SAFETY EVALUATION BY THE OFFICE OF NUCLEAR REACTOR REGULATION

PRESSURIZED THERMAL SHOCK EVALUATION

FLORIDA POWER AND LIGHT COMPANY

ST. LUCIE UNITS 1 AND 2

FIGURE 1

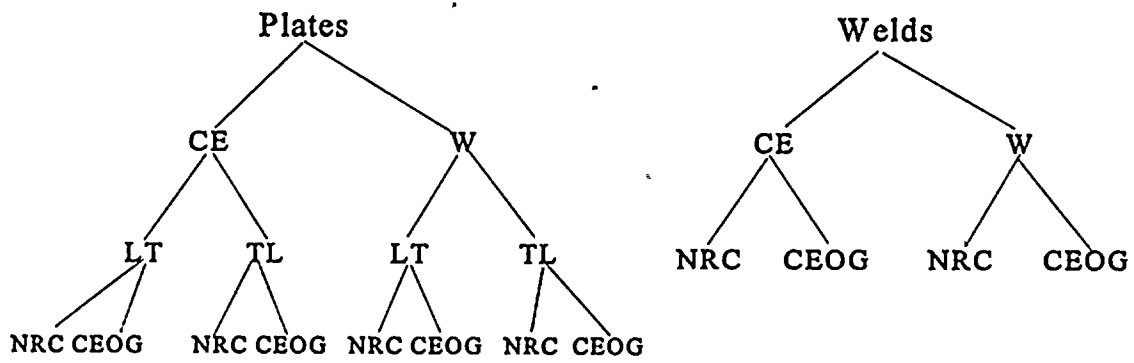
irradiation (ΔRT_{MDT}). The data are from plate and weld surveillance material that was irradiated in CE and W designed, CE fabricated vessels. The P-A values for the CE and W data were the parameters used for the staff's and the licensee's statistical analyses. Additional data with regard to plate orientation are also provided. Figure 1 shows a schematic of the method used to separate the data according to 1) material type (plate or weld), 2) vessel designer (CE or W), 3) orientation (LT or TL - plates only), and 4) data set (CEOG or NRC) for the statistical analyses.

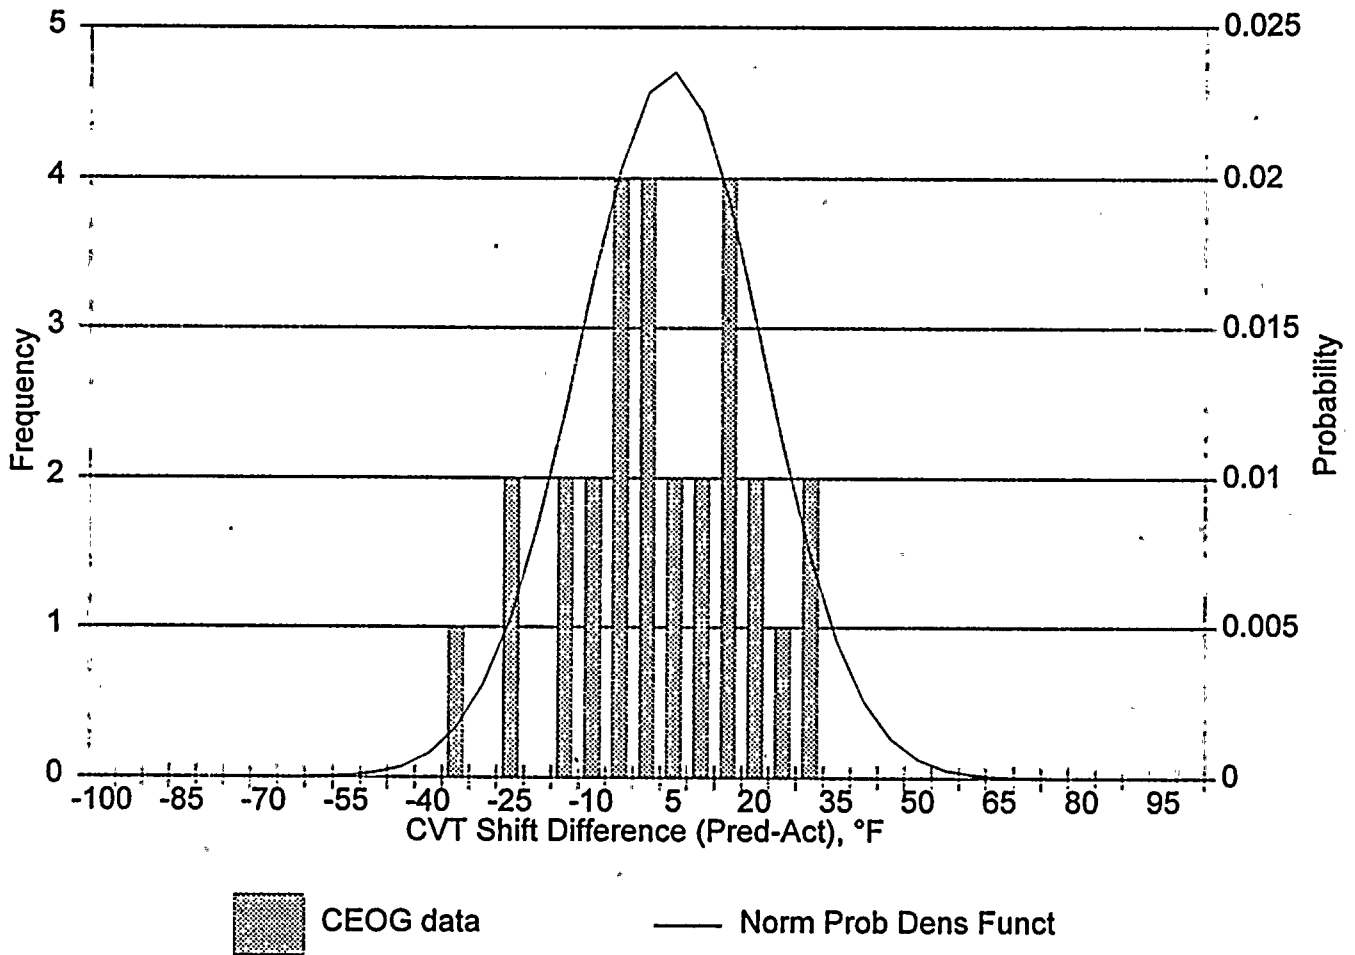
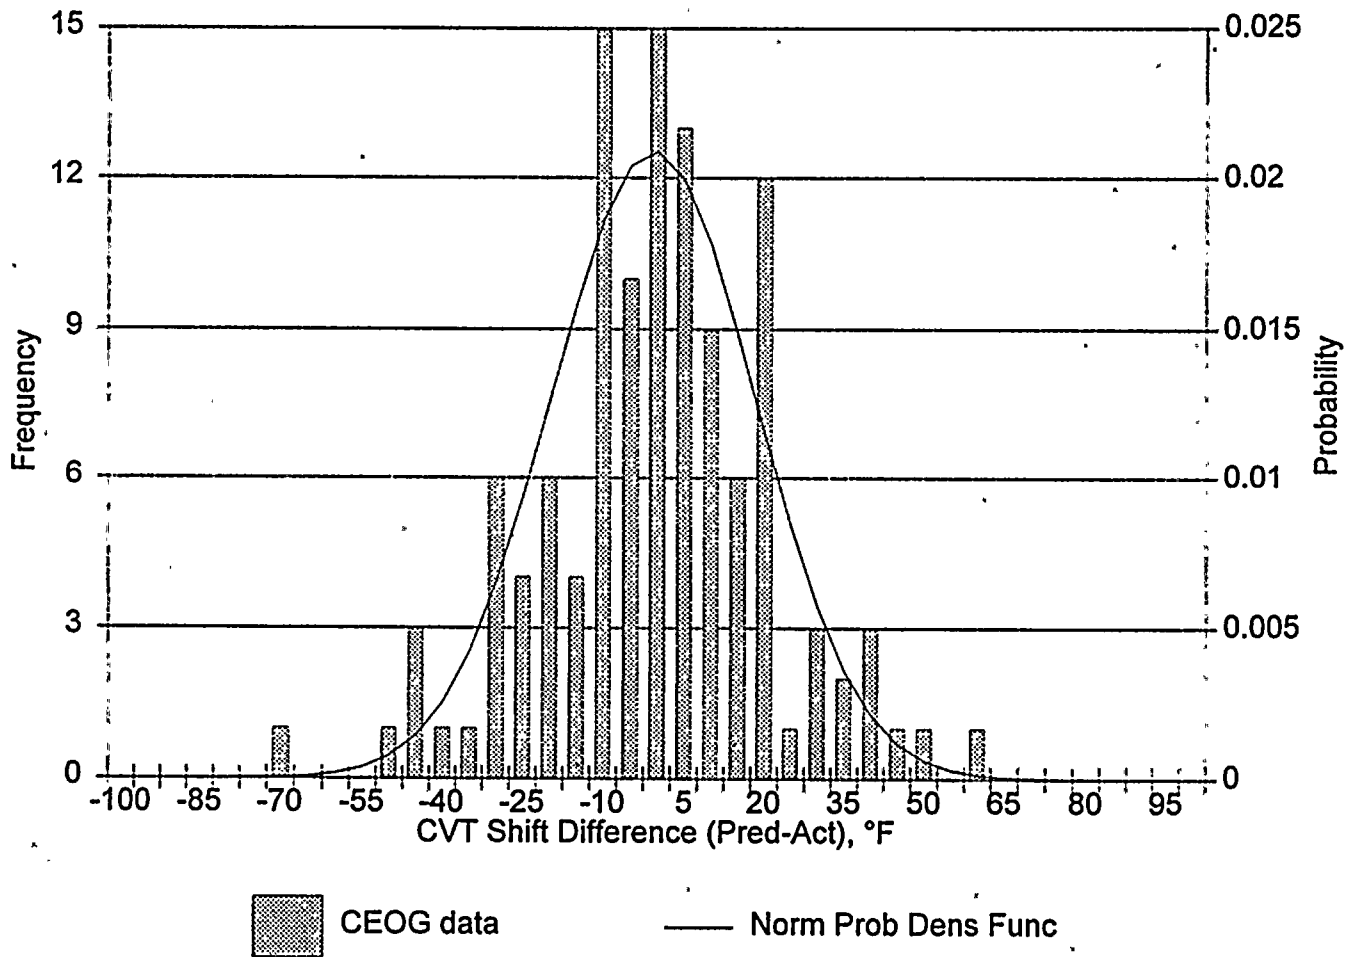
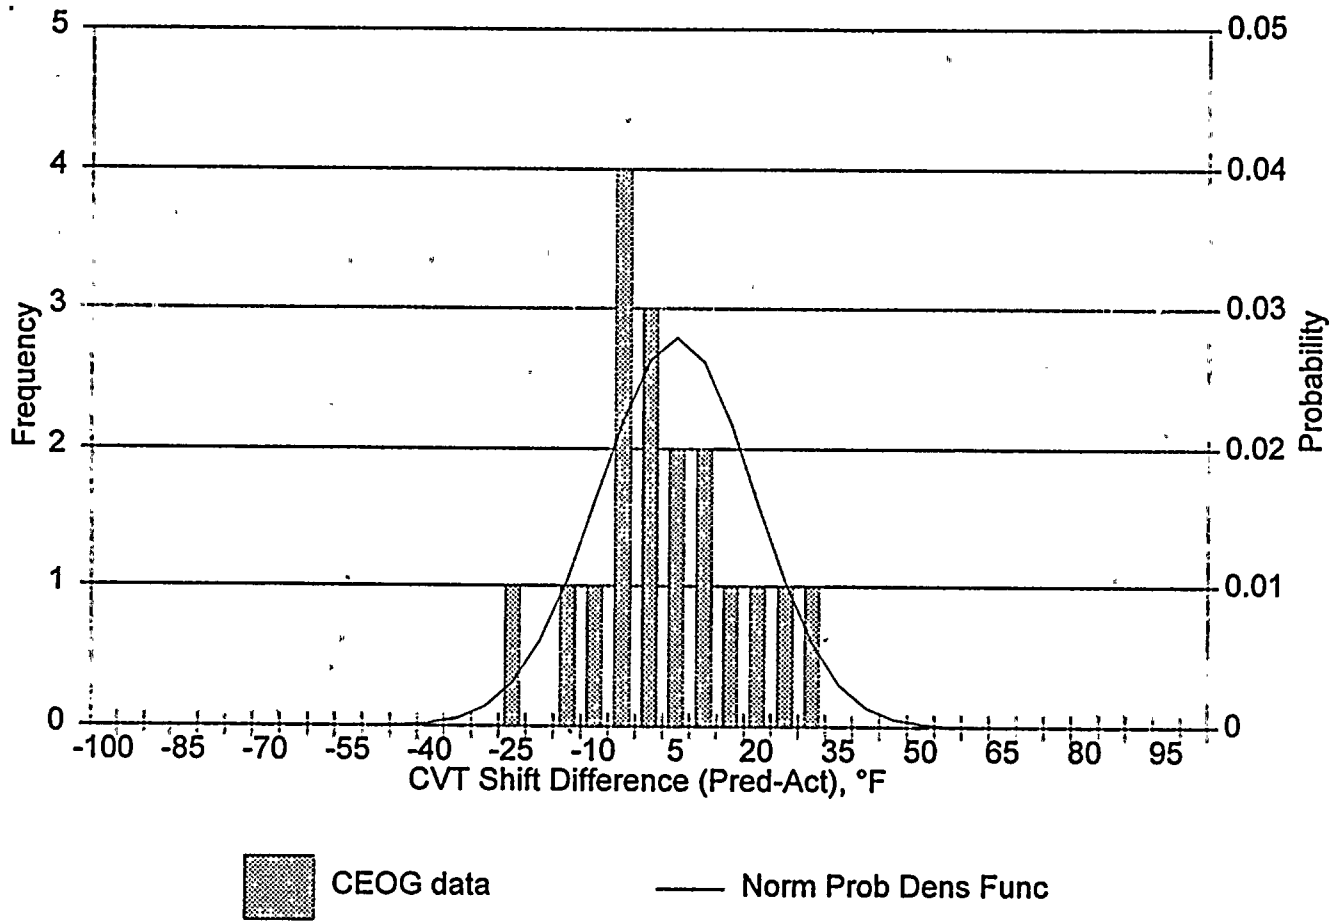
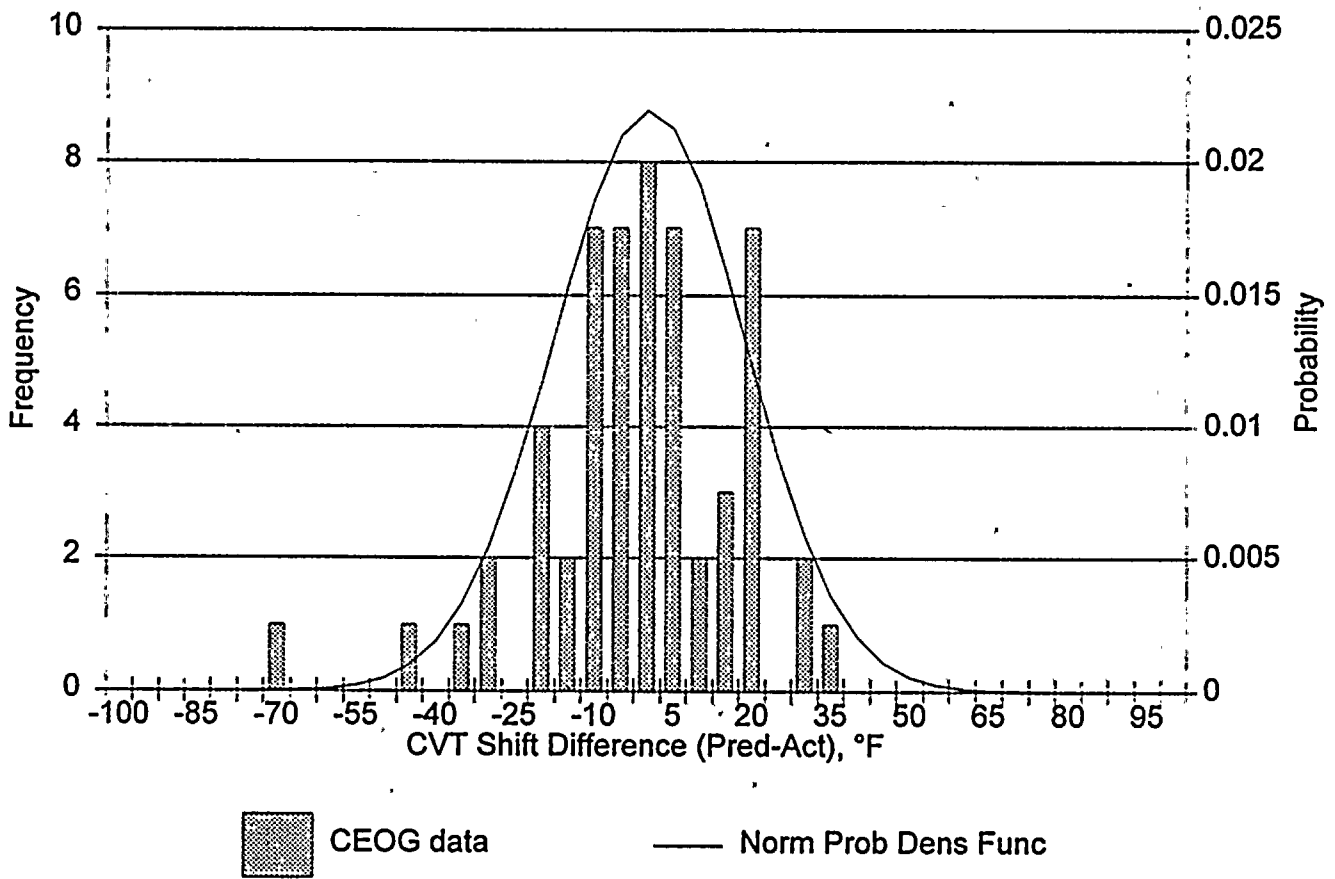
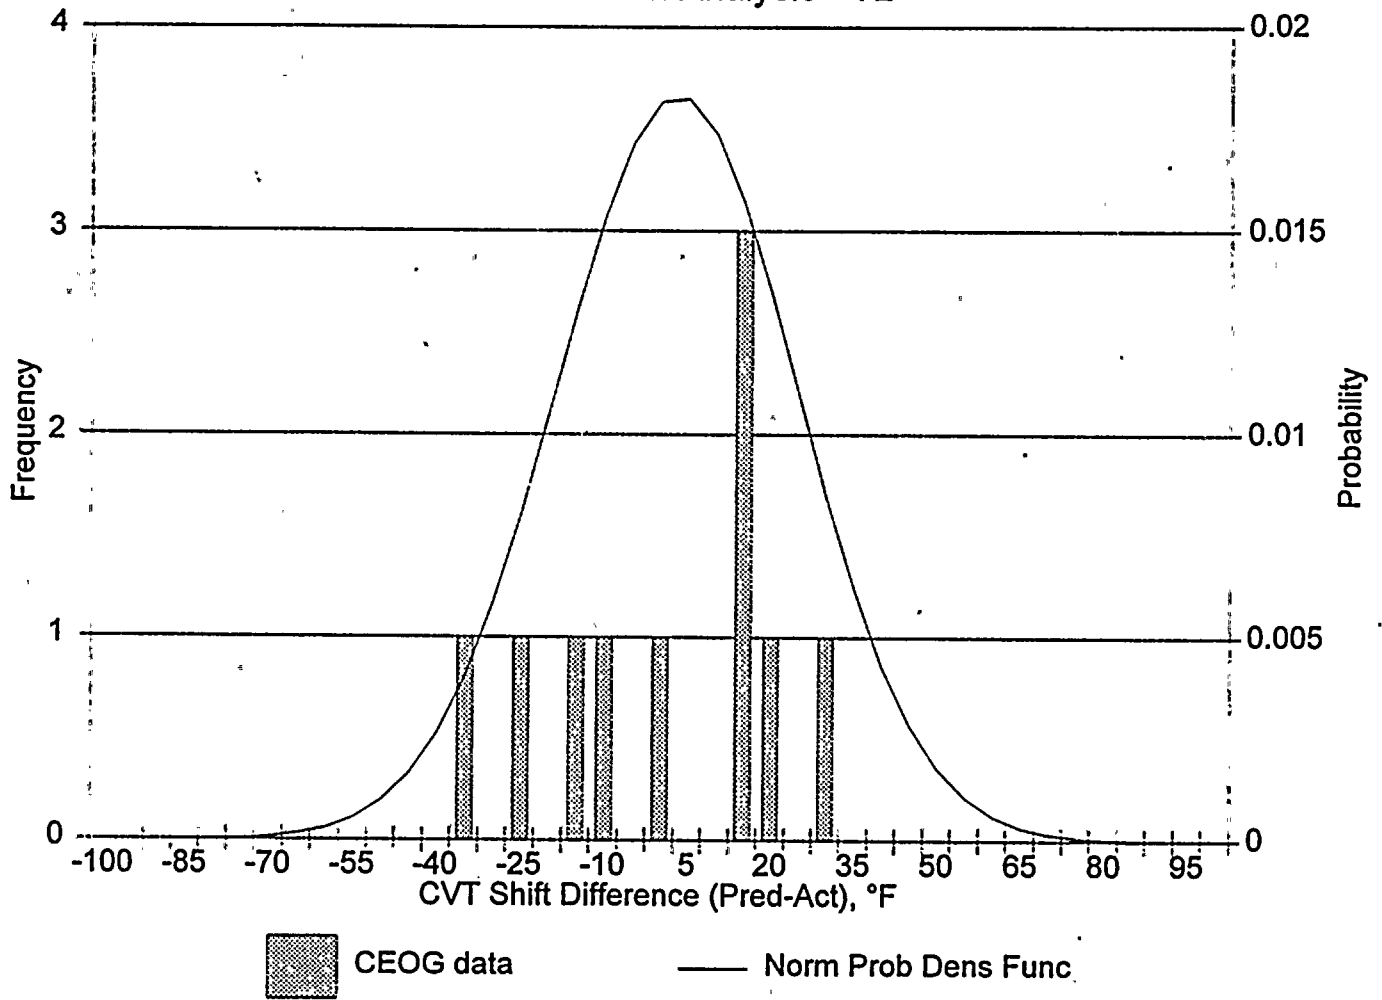
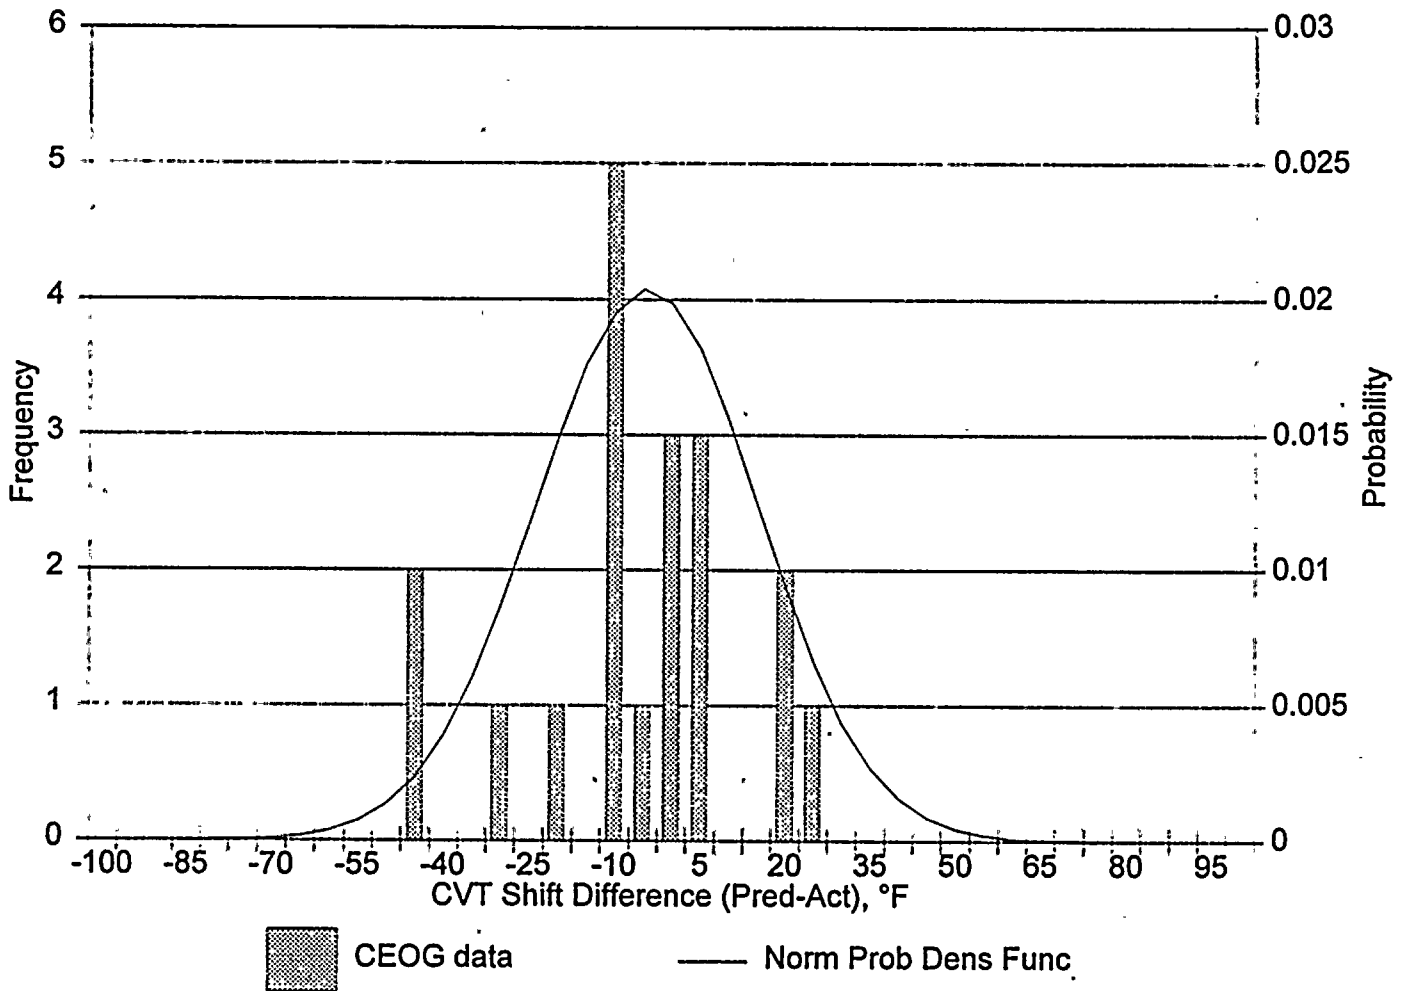
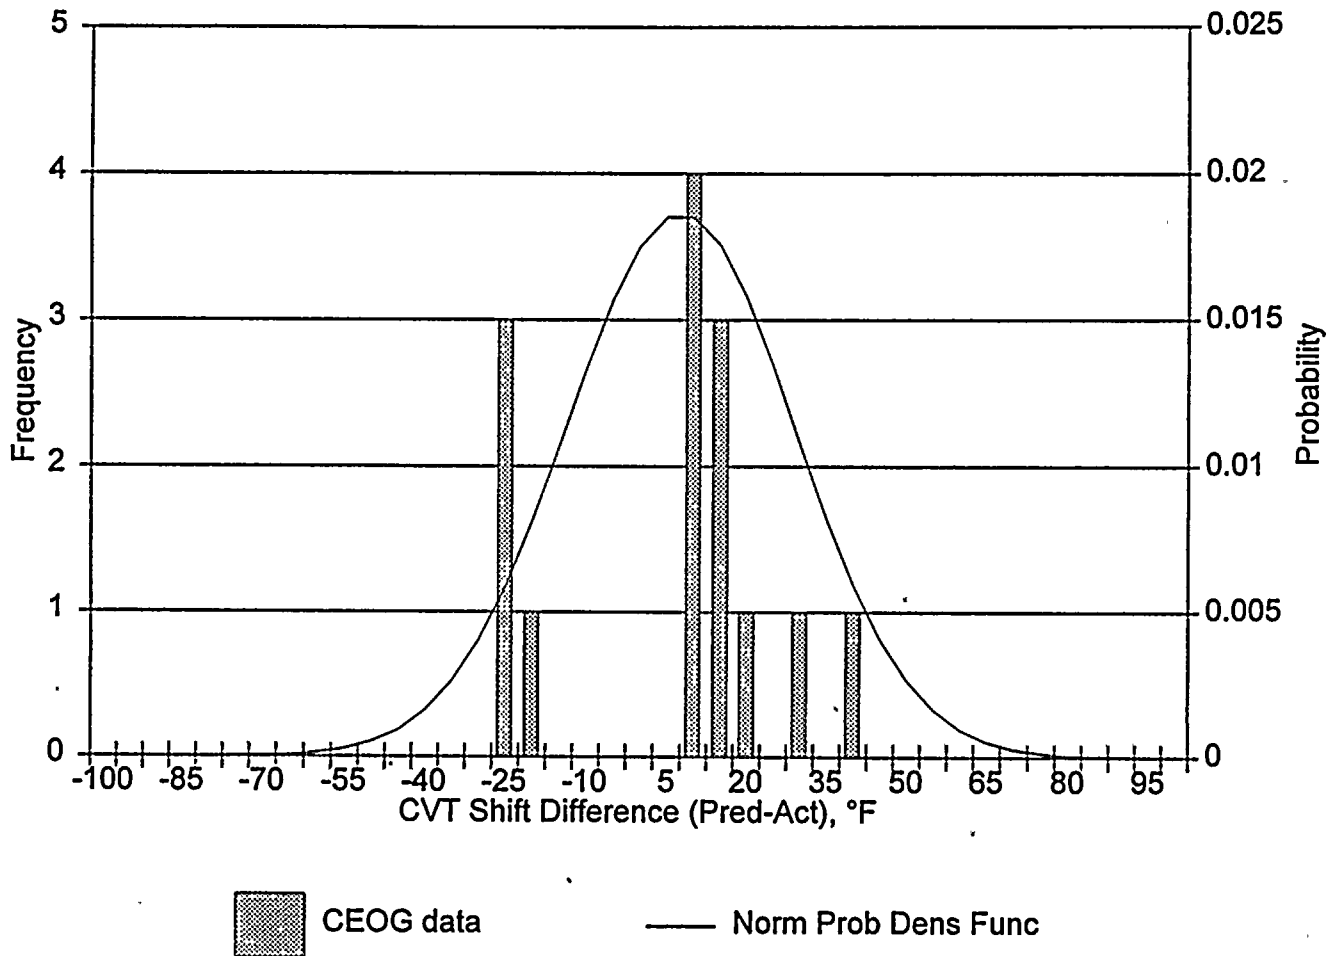
Figures 2-7, 9 and 10 present the histograms of the CEOG CE and W plate and weld data. These figures indicate the frequency of a given value as well as the normal probability distribution based on the calculated mean and standard deviation. Figures 8 and 11 present the combined CEOG CE fabricated, CE and W designed plate and weld data, respectively.

Based on the statistical analysis, the staff concluded that there is no significant difference or bias between the CE fabricated, CE and W designed surveillance data. Therefore, surveillance data from CE fabricated, CE and W designed vessels will, on average, be representative of each other for vessels fabricated in the CE Chattanooga facility.
